ANNEXURE C

Mosquito Risk Assessment
Proposed Residential Development
Lot 2 DP 1119830
Alexandra Drive
Bellwood

Supplementary Engineering Information by De Groot Benson Pty Ltd

**DEVELOPMENT APPLICATION NO, 2012/011, 346 LOT RESIDENTIAL
SUBDIVISION PLUS RESIDUE AND ASSOCIATED WORKS - STAGED,
LOT: 2 DP: 1119830 ALEXANDRA DRIVE, NAMBUCCA HEADS
Supplementary Engineering Information**

BIORETENTION CELL LAYOUT (SECTIONAL VIEW)

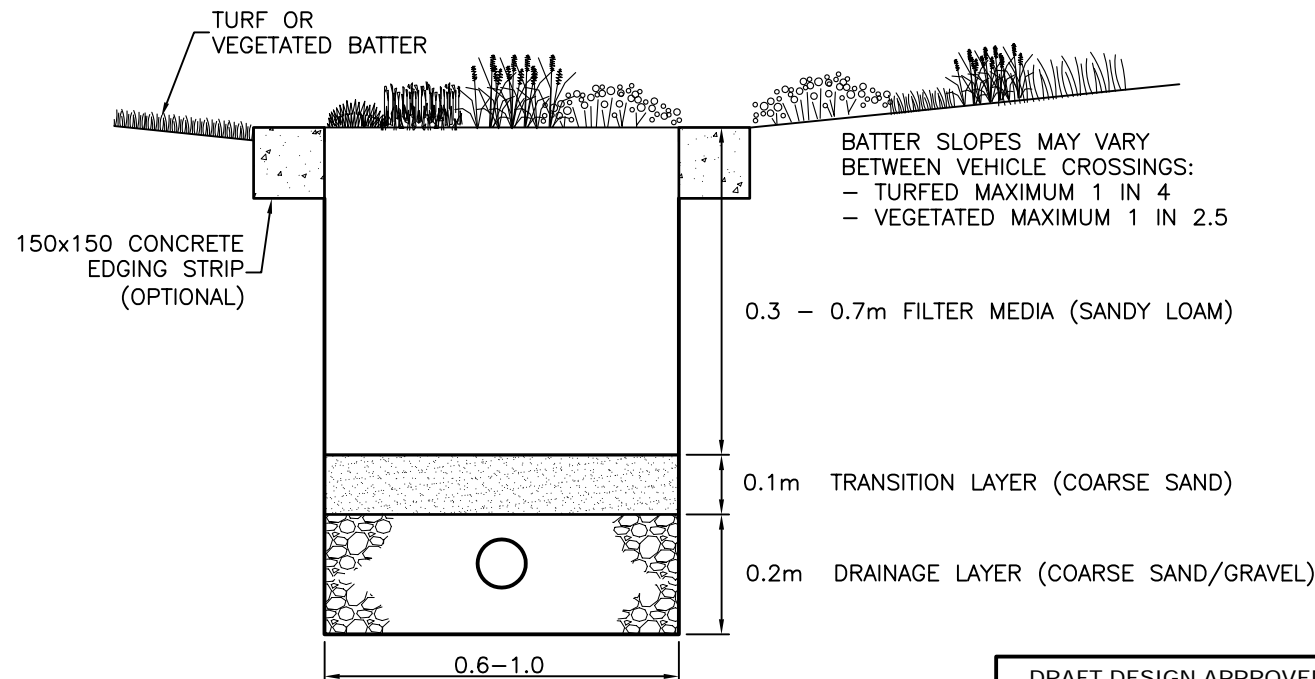
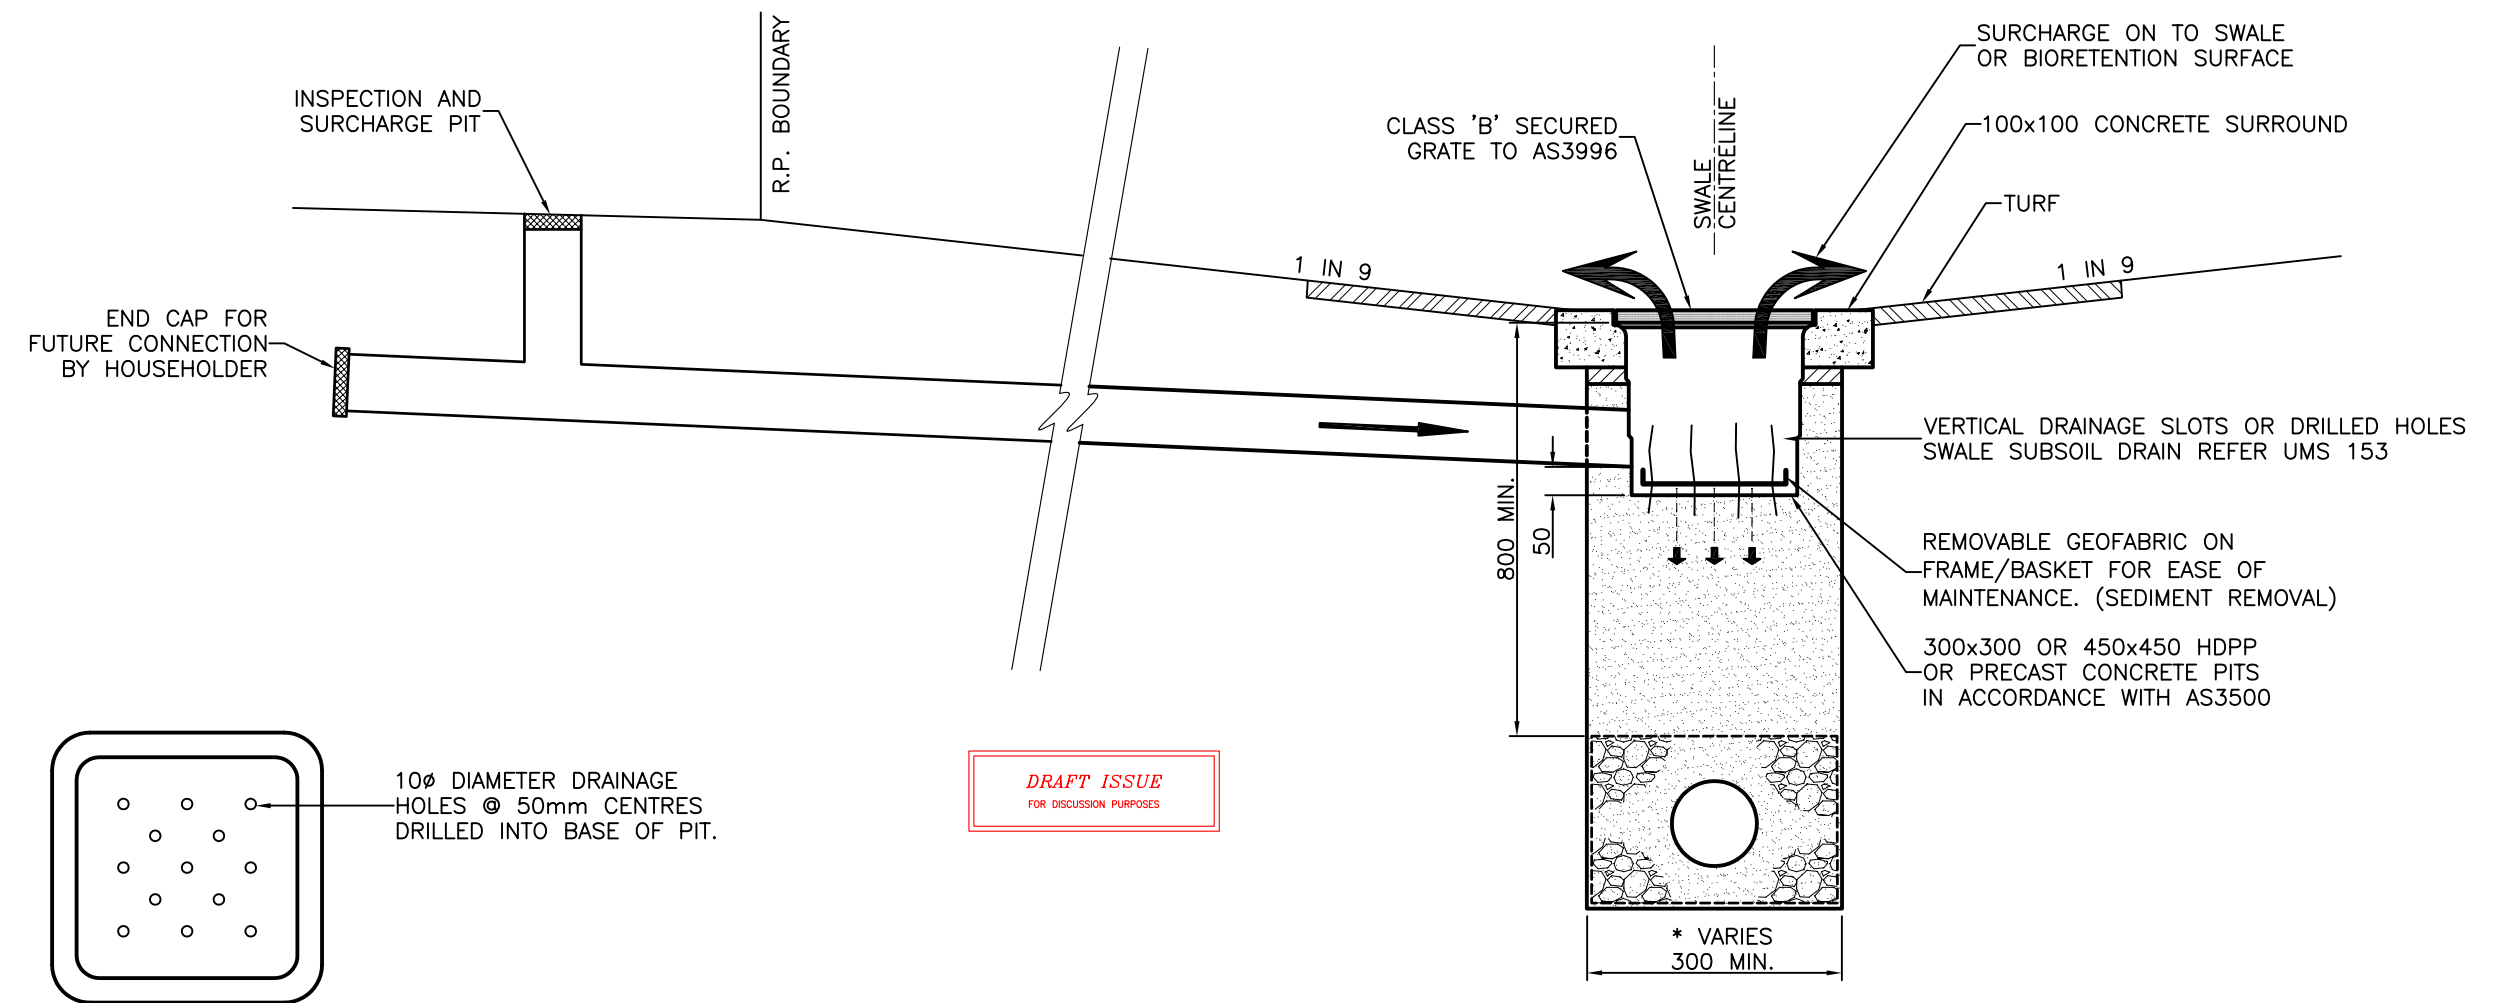
f) . Proposed kerb and gutter and swale drain design details for the proposed internal roads to the development, including relevant cross sections	In the absence of specific design guidelines from Nambucca Shire Council, we have proposed (like Coffs Harbour City Council) using those from Brisbane City Council and the South East Queensland region. Attached are standard drawings proposed for use in the design of the WSUD elements in the development.
